From: [Peter Vari](#)
To: [Stephen Havill](#); [Shontel Hunter](#); [Daniel Shaw](#)
Cc: [Sarah Wong](#)
Subject: FW: Windsor Park PPC
Date: Tuesday, 12 November 2024 11:29:10 am
Attachments: [HW Clause 23 Further Info Request - WIndsor Park PPC.docx](#)

**APPENDIX 1: FURTHER INFORMATION REQUESTED UNDER CLAUSE 23 FIRST SCHEDULE OF THE
RESOURCE MANAGEMENT ACT 1991**

Healthy Waters (stormwater) – Lee Te, Senior Healthy Waters Specialist, Healthy Waters, Auckland Council.....

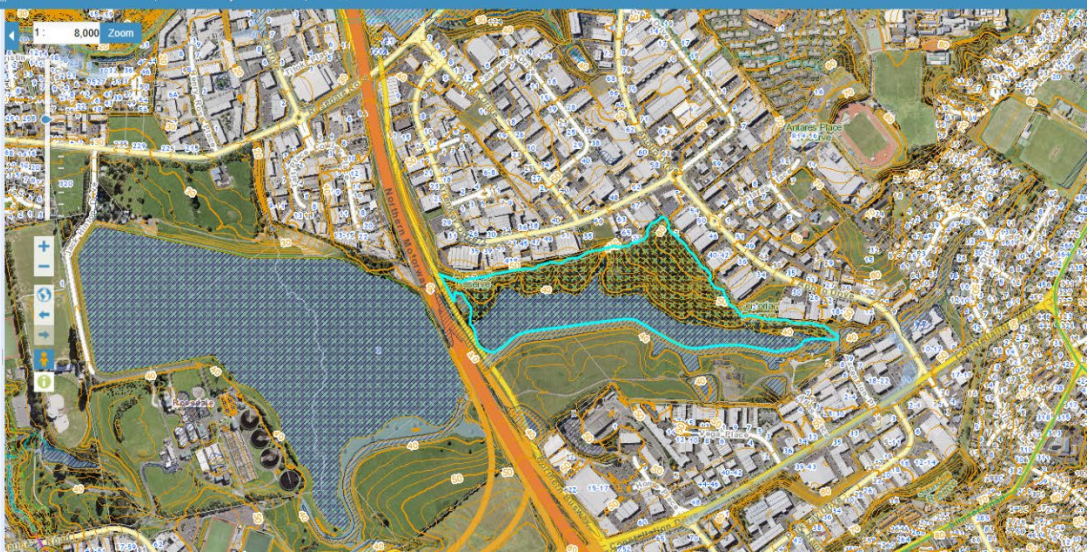
pipes.

Until this plan is available and a specific development proposal prepared, we cannot comment any further apart from stating the build overs should be avoided where possible.
